**Zoning Board of Appeals
June 24, 2015 Regular Meeting**

STAFF REPORT

Subject: ZBA15-013, 580 Liberty Pointe

Summary: John Leppiaho is requesting one variance from Chapter 55(Zoning) Section 5:32 (Multiple-family, R4A), of 8 feet for expansion of an existing residential structure into the side setback, 20 feet is required.

CHECKED BY: Joe Palmer
 DRAWN BY: Joe Palmer
 DRAWING: SITE PLAN
 SCALE: 1" = 40' - 0"
 SHEET: C-101

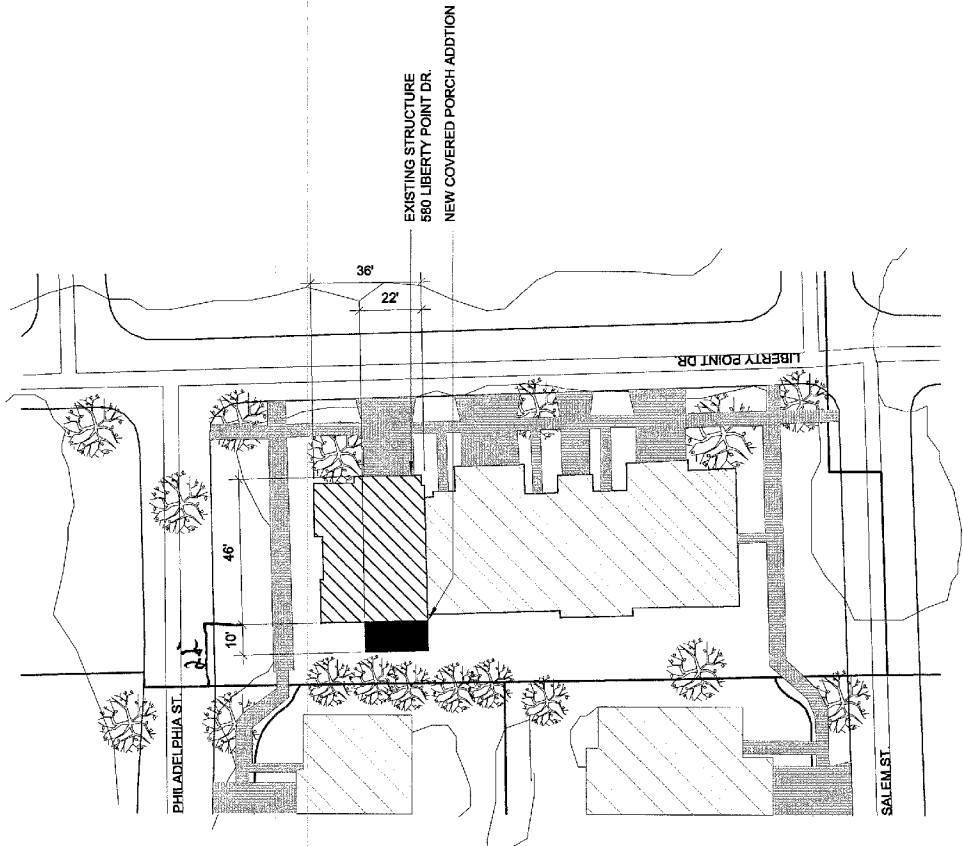
The petitioner is proposing to construct a covered and enclosed 10 foot by 21 foot 11 inch, 220-square foot addition to the existing house. The proposed addition will be located behind the structure and will match the footprint of the existing deck. It will not be built any closer to the side property line than the existing unenclosed deck along the rear of the house. The new addition will be 12 feet (required setback is 20 feet) from the side property line and will match the architectural style and roofline of the existing structure.

The proposed addition is the same footprint as the existing deck. The requested variance is required only to enclose and cover this area. A smaller deck could be proposed, but would still require a variance due to the location of the building 2 feet from the required side setback.
